## **CAR's Reply to the ICCT's "Comments on the Center for Automotive Research (CAR) June 2011 Report 'The U.S. Automotive Market and Industry in 2025' "**

### **Center for Automotive Research July 18, 2011**

Figure 1. Baseline 2025 market share, market share at 56 and 62 m.p.g. using HEV/PHEV constraints in CAR report, and market share at 56 and 62 m.p.g. for an unconstrained HEV market.

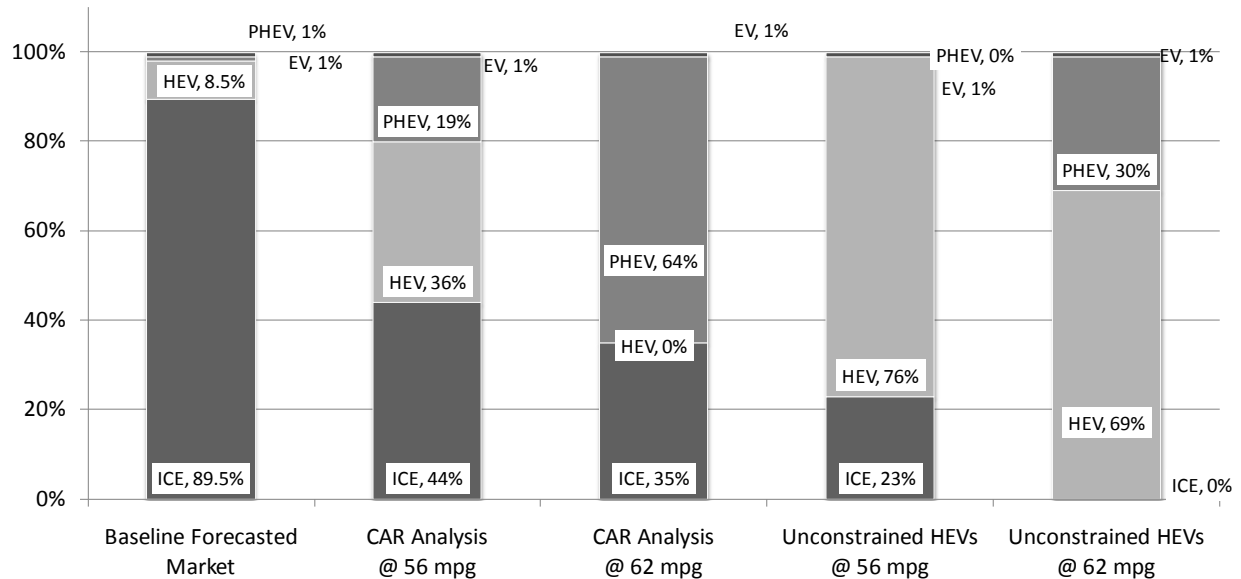
11. ICCT: Finally, the report includes large numbers of BEVs and PHEVs in its scenarios, instead of first increasing HEV sales. This not only overstates vehicle costs, but also the costs of charging equipment, which CAR calculated to be \$40/vehicle for the 3% scenario, \$175 for 4%, \$348 for 5%, and \$1,105 for 6%. The HEV constraints put in table 4 (page 15) are unrealistic. As they admit on page 22, "An alternative to this scenario (assuming no PEV market penetration) would require over 80 percent HEV market share—also drastic by today's predictions." 80% market share of HEVs in 2025 is far less drastic than 64% market share of PHEVs in 2025. Rather than constraining HEV shares while letting PHEV shares go unrestricted, CAR should restrict the PHEV market share.

The figure on page 8 demonstrates the divergence of the baseline forecasted market share utilized by the CAR study against the CAR analysis and an alternative unconstrained HEV market at 56 and 62 m.p.g. Both the constrained and unconstrained markets are in complete disagreement with the baseline market forecasts. At 62 m.p.g., with an unconstrained HEV market, the 90% internal combustion engine market would be replaced by a 100% BEV, PHEV, and HEV market.
